Haverhill

July 22, 2019

RE: City of Haverhill Water Pollution Abatement Facility (WPAF)
Comment on NPDES Draft Permit MA0101621

Figure 1. Annual 7-Day Low Flows from 1923 to 2018.

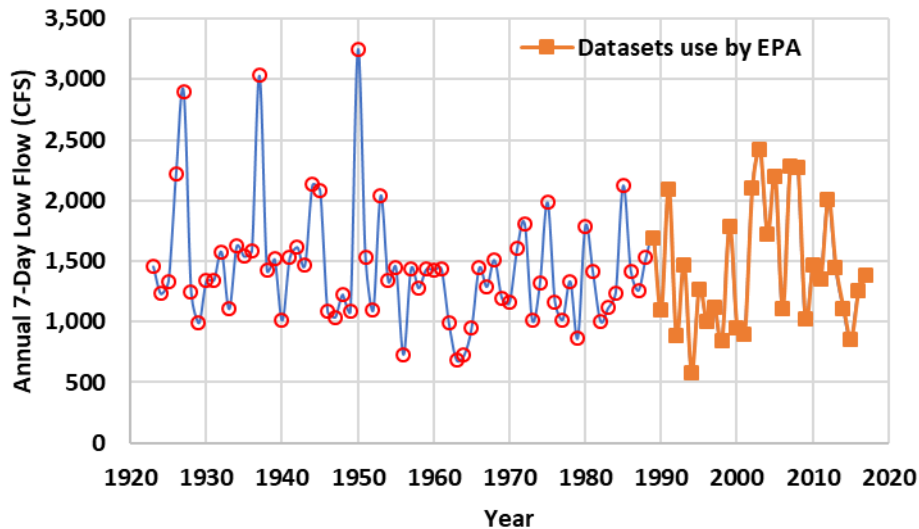
- a) Smaller Number of Dataset Used to Calculate 7Q10 Causes Higher Uncertainty in Statistical Analysis: EPA extrapolated 7Q10 flow from a portion of USGS data set of river daily discharge data (January 1989 to October 2017) as stated in 2019 Fact Sheet page 14 of 41. It is unclear why this 30-year period was selected even though USGS data set included data from June 1923 to December 2018.

The statistical estimate of 7Q10 flow was based on log Pearson Type III distribution to fit the return frequency curve with annual 7-day low flow data. For statistical analysis, the larger the dataset available, the greater the certainty of the estimated value. The Figure below shows the annual 7-day low flow values from 1923 to 2018. There is no observable trend over the entire 95-year period.

Table below compares 95 percent confidence intervals with Log Pearson Type III distribution analysis using entire 95 years of data versus only using most recent 30 years of data. The comparison indicates that using a smaller sample number in deriving the 7Q10 results in much higher uncertainty (reflected in a much higher discrepancy over the 95 percent confidence interval (from 637.500 to 988.060 cfs). The Log Pearson Type III analysis results are included in Attachment 2.

Request: To provide a more accurate estimate of 7Q10 flow with less uncertainty, EPA should use all river discharge data available (June 1923 to December 2018) for USGS gage (#01100000). It is also consistent with the example described in EPA’s Handbook for NPDES Permit Writers for calculating the 7Q10².

Figure 2 Low Flow Return Frequency Statistical Graph for USGS Gauge Station 01100000 Using USGS SW Toolbox Version 1.0.4³. The calculated 7Q10 flow is 907.33 cfs. The Analytical processes are based on EPA’s Handbook for NPDES Permit Writers.

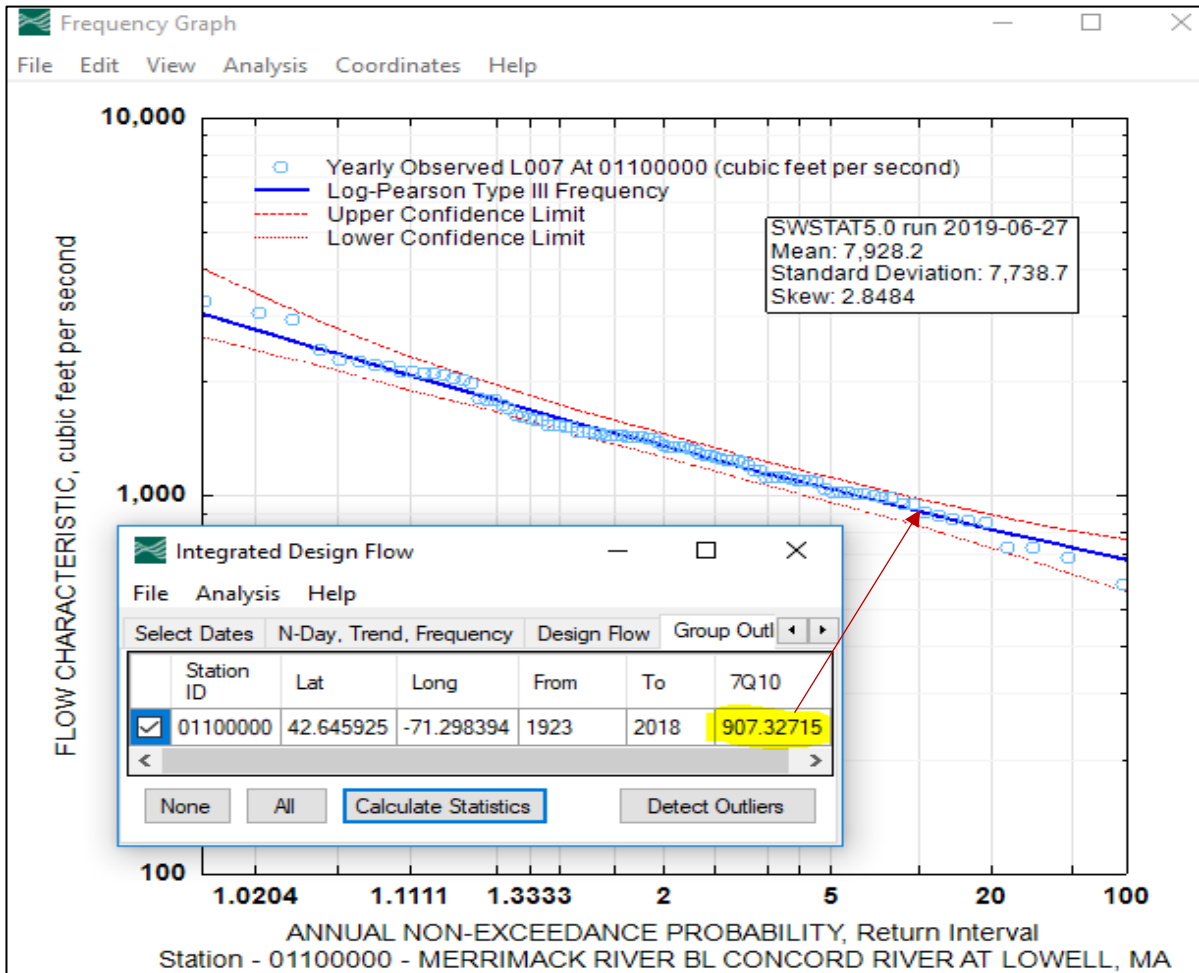
- b) Calculated 7Q10 Provided in the Draft Permit at USGS Gage Station (#01100000) is Incorrect: EPA provided a 7Q10 flow of 832 cfs in 2019 Fact Sheet page 14 of 41. However, there is no description of how this value was estimated. Based on the methodology described in EPA’s 2018, Low Flow Statistics Tools, A How-To Handbook for NPDES Permit Writers and USGS’ SW Toolbox software, the City recalculated the 7Q10 value for the USGS gage station (#01100000) with all available data. The 7Q10 for this gage station is estimated to be 907.33 cfs as illustrated in Figure 2 below as well as shown in Attachment 2.

Request: Based on EPA’s Handbook for Permit Writers on estimating 7Q10 value, the City has calculated 7Q10 value for USGS gage station (#01100000) to be 907.33 cfs. The City requests that EPA replace the 7Q10 value with updated estimation of 907.33 cfs.
